**TRANSMITTAL OF DOCUMENT CHANGE NOTICE #1486, FERNALD CLOSURE PROJECT,
WASTE PIT PROJECT, CLOSURE OF CLEARWELL AND PROCESS WATER ROUTING TO
STORMWATER MANAGEMENT POND**

Clearwell Closure Plan – 08JUN04

Engineering / Document Change Notice

Shaw Project No. 773481 / FF No. 98SC000001		Project Name: WPRAP	PCP: N/A
Subject: Process Water Routing to SWM Pond			
Type of Change: ECN _____ DCN <u> X </u>	Change Class: Class 1 _____ (PCP Req'd) Class 2 _____ (PCP Req'd) Class 3 <u> X </u> (Minor Mod)	Change Number: 1486	Issue Date: 06/04/04 Page <u> 1 </u> of <u> 3 </u>
Reason for Change: Reference DCN 1466 04/08/04 and DCN 1475 05/21/04. Closure of the Clearwell and continued operations require the utilization of the SWM Pond as the primary collection point for contact surface water from excavation, blowdown, and building sumps.			
Description of Change: In DCN 1466, a 2 nd submersible pump (P-9081) was added to the truckwash settling basin in addition to P-9080. P-9080 and P-9081 have 400-500ft 4" HDPE discharges direct to the clearwell. 12"PW-9021-UW, which delivers surface water from the plant and haul road sumps to the clearwell was re-directed from the point near the BSL where it

DESIGNED BY	PMS	CHECKED BY	PA	2/1/99	REVISION
DRAWN BY	COB	APPROVED BY	JAM	2/1/99	
DATE	2/1/99	DWG. SCALE	NONE		
PROJECT NO.	773481	DRAWING NO.	D-65-11-002

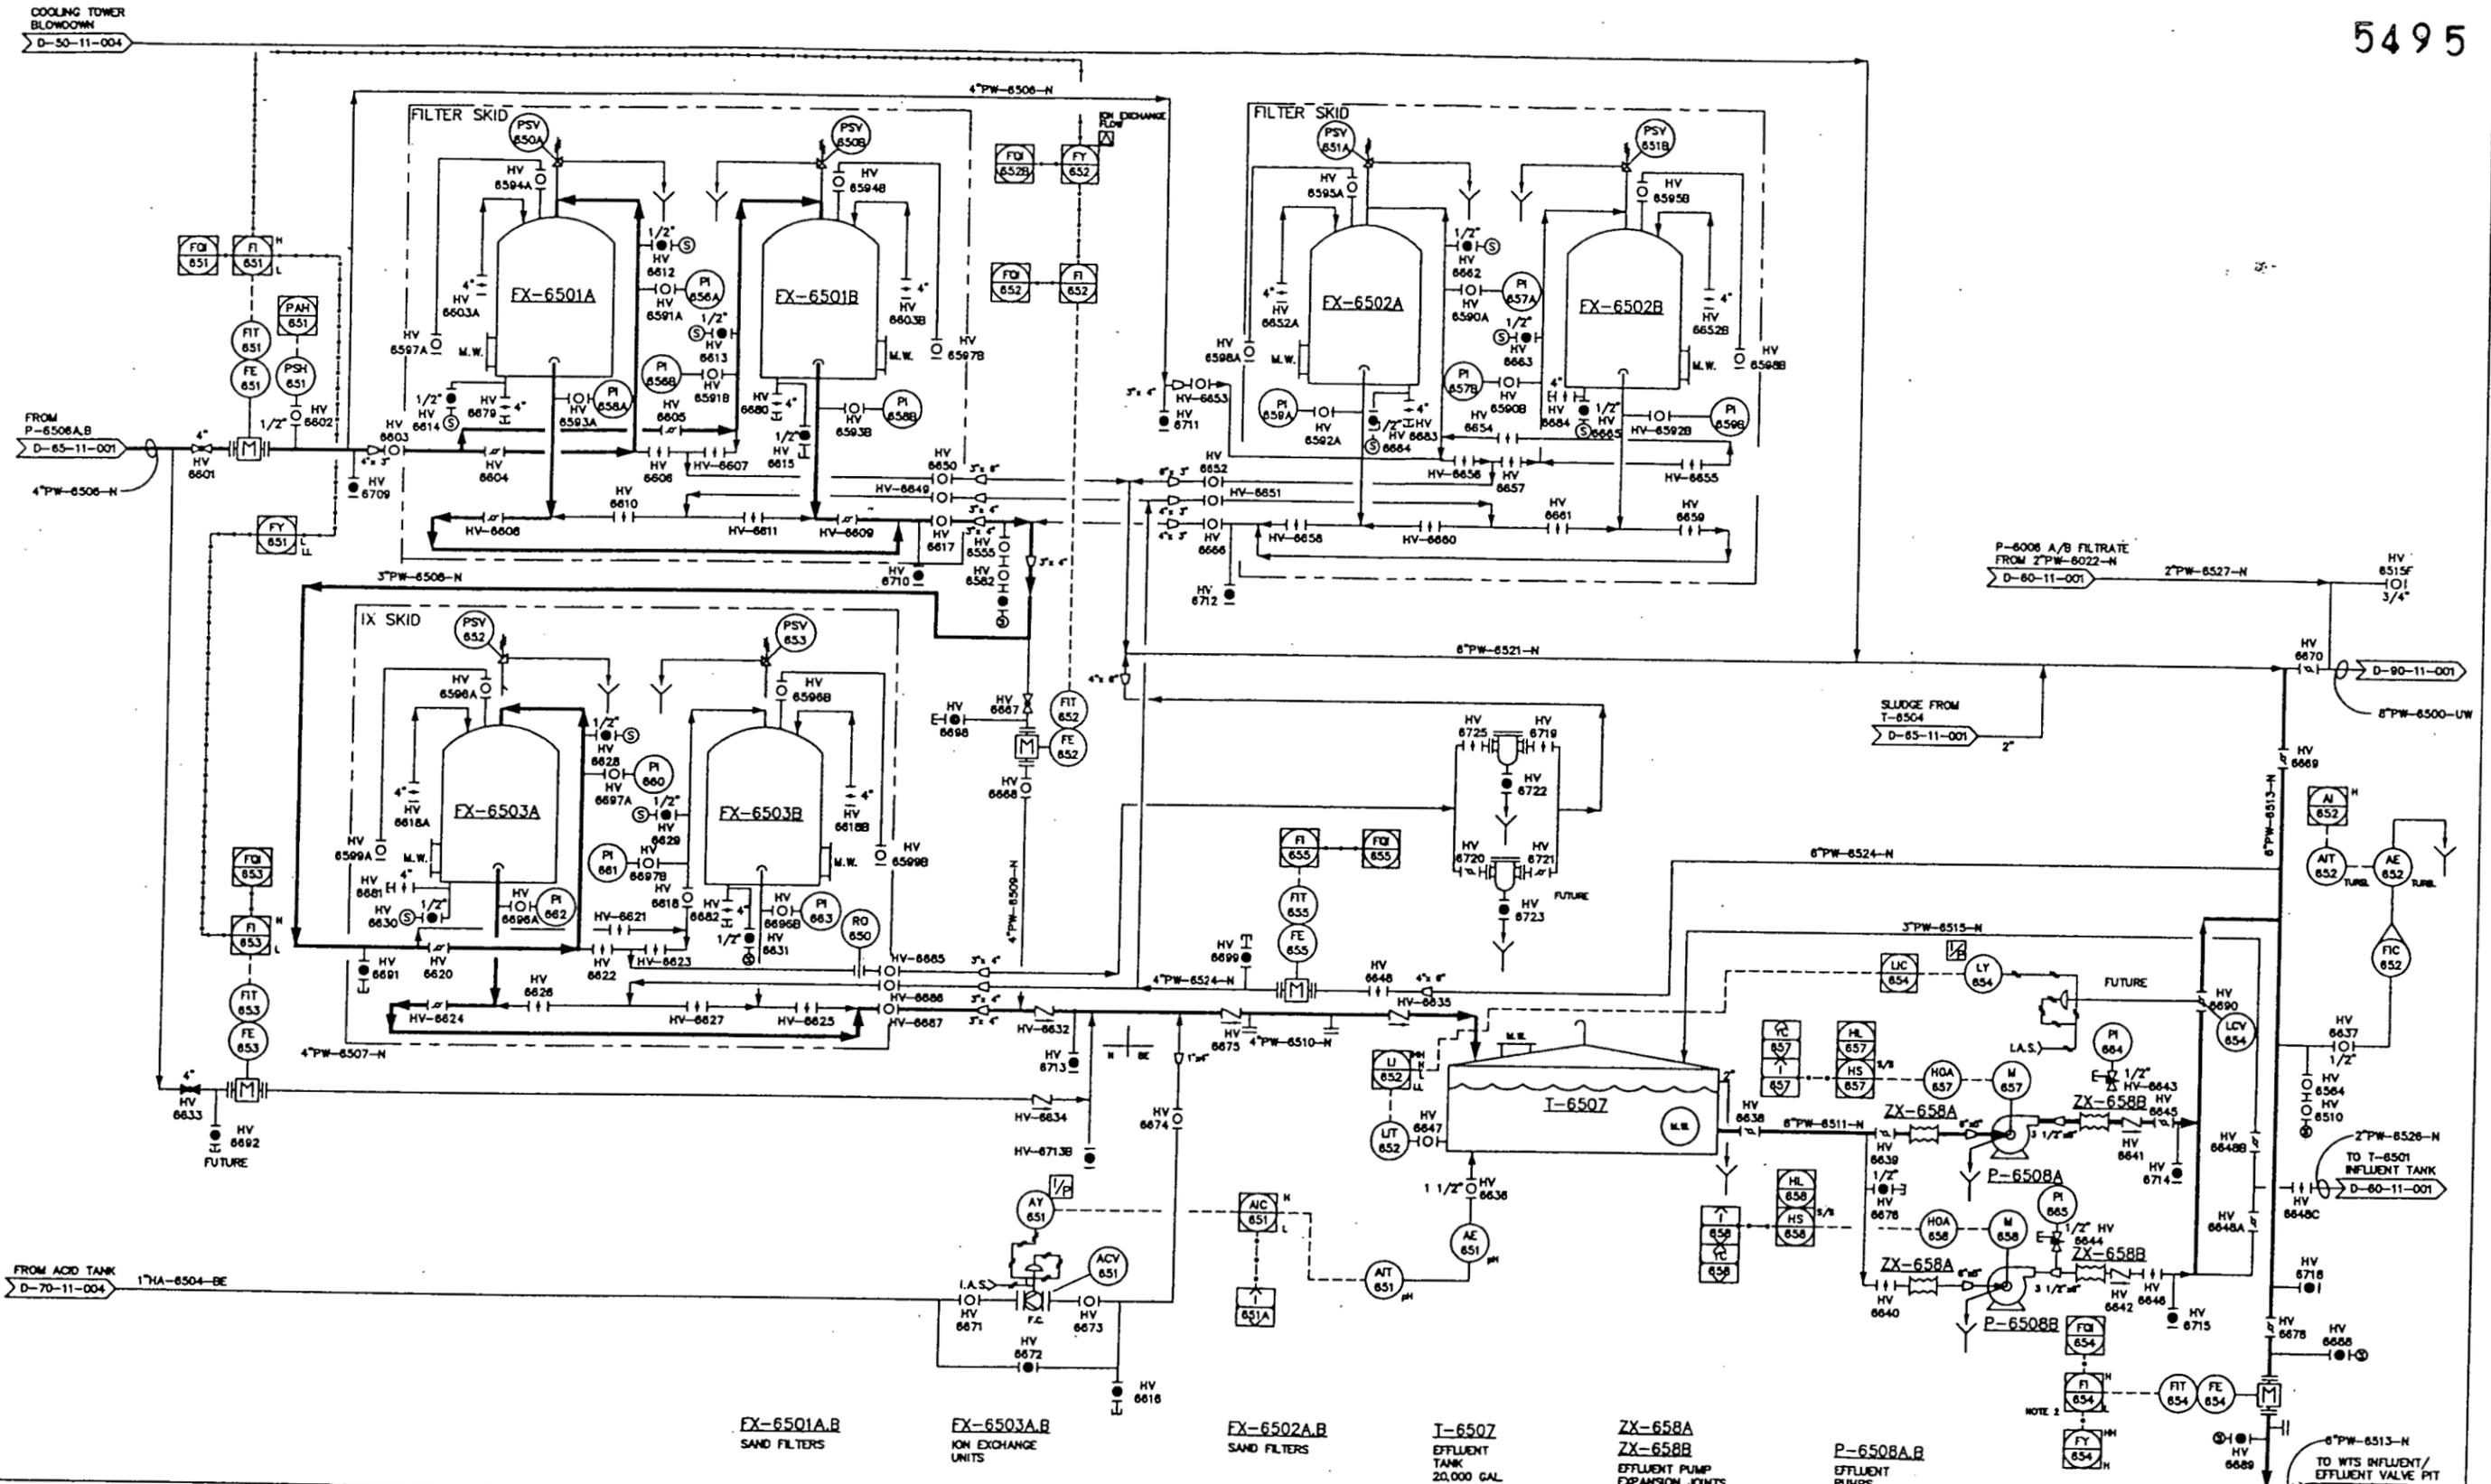
- D-65-11-002: removed reference to clearwell for D-90-11-001 blowdown.
- D-90-11-001: removed excavation pumps on line to truckwash basin 12" PW-6500-UW.

- NOTES:
1. ALL SECONDARY PUMPS ARE INSTALLED SPARES.
 2. 24-HR. AVERAGE
 3. TFE LINED T (USE BE SPEC.)
 4. DCN 1384 06/09/03: ADDED 2" PW-6526-N TO P-6508 DISCHARGE RECYCLE; ADDED 2" PW-6527-N TO 6" PW-6500-UW
 5. DCN 1486 06/04/04: CHANGED AREA 65 BLOWDOWNS REFERENCE TO CLEARWELL

DESIGNED BY	SJL	CHECKED BY	BAH	5/8/99	REVISION
DRAWN BY	JMH	APPROVED BY	JAM	5/8/99	
DATE	4/28/98	DWG. SCALE	NONE		
IT PROJECT NO.	773481	DRAWING NO.	D-90-11-004

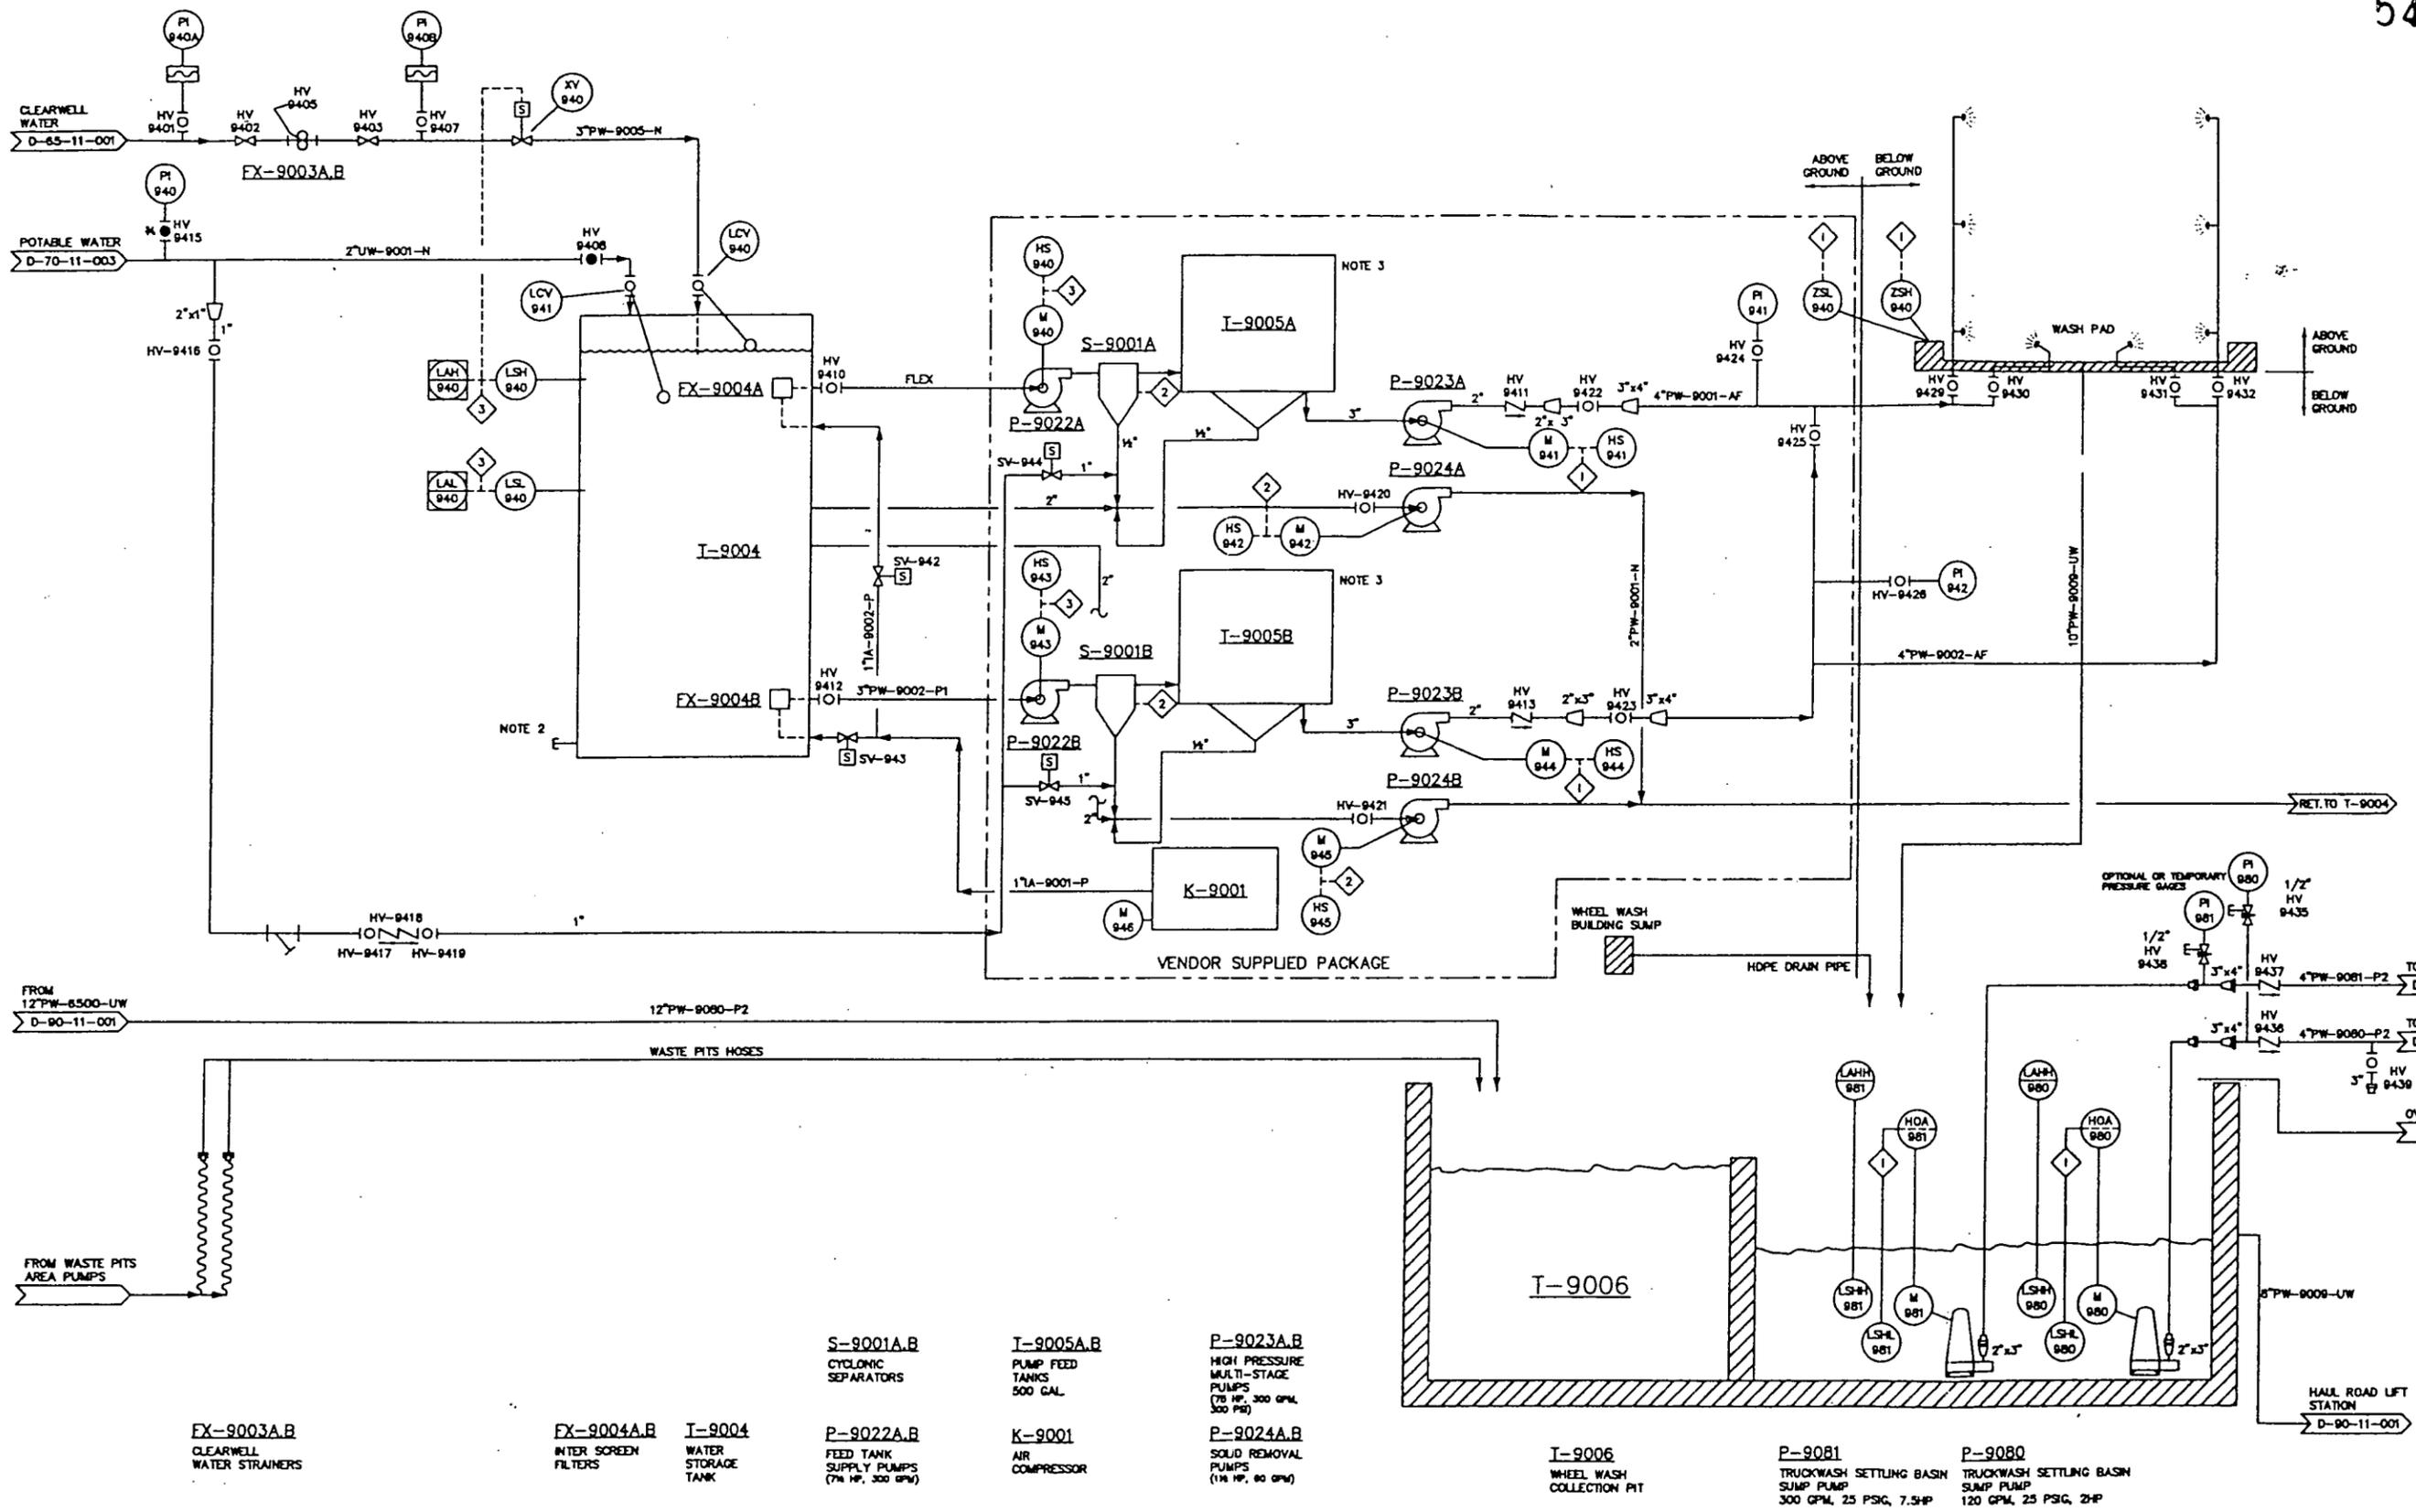
- D-90-11-004: showed waste pits pumps direct to settling basin, overflow to Ppit 2, and P-9080/9081 effluent to D-05-11-002 (SWM Pond)

1. FUTURE CONNECTION TO P-9022A/B INLET PIPING.
2. TANK HAS 3 PLUGGED DRAINS
3. TANK HAS 3 LEVEL SWITCHES
4. DCN 1403: REVISED LOCATION OF 4"PW-9002-AF
5. DCN 1486: ADDED 2ND P-9081 PUMP, 12"PW-9080-P2
6. DCN 1486 06/04/04: REFLECTED EXCAVATION PUMPS DIRECT TO SETTLING BASIN T-9006. ADDED SETTLING BASIN P-9080/9081 DISCHARGE TO SWM POND
